# VALIDATION REPORT

**Kuyucak 25.6 MW Wind Farm Project, Turkey**

<b>Subject:</b>			
Validation pursuant to Art. 12 of the Kyoto Protocol and Gold Standard requirements			
<b>Validation Team:</b>			
Dr. Jochen Gross – Lead Assessor		<input checked="" type="checkbox"/> No Distribution (without permission from the Client or responsible organisational unit)	
Dr. Reiner Huba – Expert, Trainee Lead Assessor			
Aslihan Cetin - Trainee Local Assessor			
<b>Technical Review:</b>		<b>Trainee Technical Reviewer:</b>	
Date: 28/04/2009		Name: Not Applicable	
Name: Irma Lubrecht		<input type="checkbox"/> Limited Distribution	
<b>Authorised Signatory:</b>			
Name: Siddharth Yadav		<input type="checkbox"/> Unrestricted Distribution	
Date: 1 <sup>st</sup> June 2009			
<b>Revision Number:</b>	<b>Date:</b>		
0	11/12/2008	92	
1	17/03/2009	94	
2	06/05/2009	86

Figure 2. Single line layout for the Çataltepe 16 MW wind farm

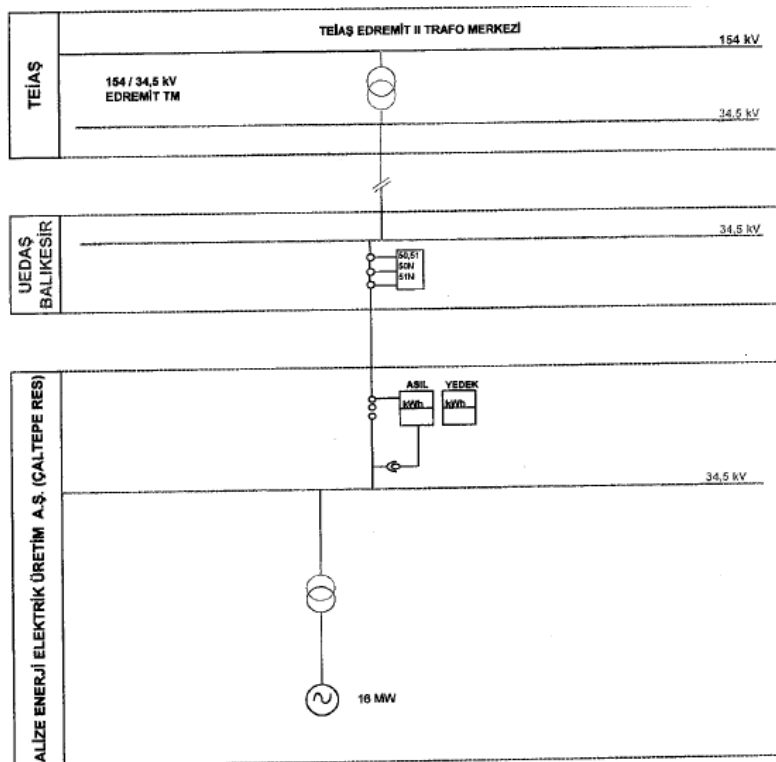
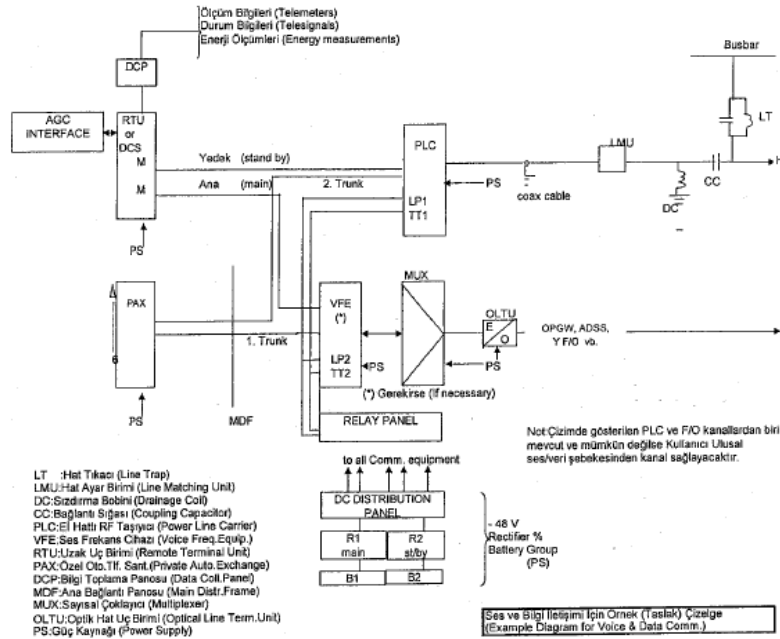
Date:	05/08/2008			Raised by:	Reiner Huba		
No.:	4	Type:	CAR	Issue:	Monitoring plan and corresponding procedures are insufficient	Ref.:	B.11.1-3, B.11.5, B.12.1-2, B.13, F.1.1.2
Lead Assessor Comment					Date: 05/08/2008		
<p>a. SD indicators are not included in monitoring, please add to revised monitoring plan</p> <p>b. Competences, responsibilities not defined, please add to revised monitoring plan</p> <p>c. Day-to-day record handling and archiving not defined, please add to revised monitoring plan</p> <p>d. Fall back options, emergency preparedness, default values and potential data adjustments, not defined, please add to revised monitoring plan</p> <p>e. Report templates not defined, please add as e.g. demonstrated for the recent project Mare Anemon</p> <p>f. monitoring of self-consumption is missing, please add to monitoring plan</p> <p>g. description insufficient, please describe monitoring methodology in more detail</p> <p>h. uncertainty is missing, please add</p> <p>i. QA/QS system not treated, e.g. training, internal auditing, implementation of improvements, reviewing, please explain QA/QS system (for all parameters)</p>

A single-line connection plan for the Çataltepe 16 MW wind farm is given below. Final connection plans for other projects are not finalized yet, however the same technical layout applies for them as well. Two measurement devices measure the electricity generation and consumption and afterwards the generated electricity is supplied to the transformer station, after which the transmission line connects to the medium- or high-voltage electricity grid.

The attached connection agreements have also a detailed description of technical requirements guaranteeing accurate calculation of emission reductions in a most conservative way, as the conditions of the agreement are mostly in favour of the line operator. The Annexes of the agreements provide detailed technical information about the tasks under various scenarios (when, how, by whom etc.), therefore the line operator very much attends to the Quality Assurance and Quality System issues. The Annexes cover the following subjects: 1-Connection Details, 2-Project Boundaries, 3-Safety System, 4-Initial Test Procedures.

<p>Reasoning for not acceptance or acceptance and close out:          Because of the detailed information and documents provided especially the revised monitoring plan CAR-4 a-h can be closed out, CAR-4 i is still open.          Because of the information provided, last on 26<sup>th</sup> November CAR-4 was closed out in total.</p>
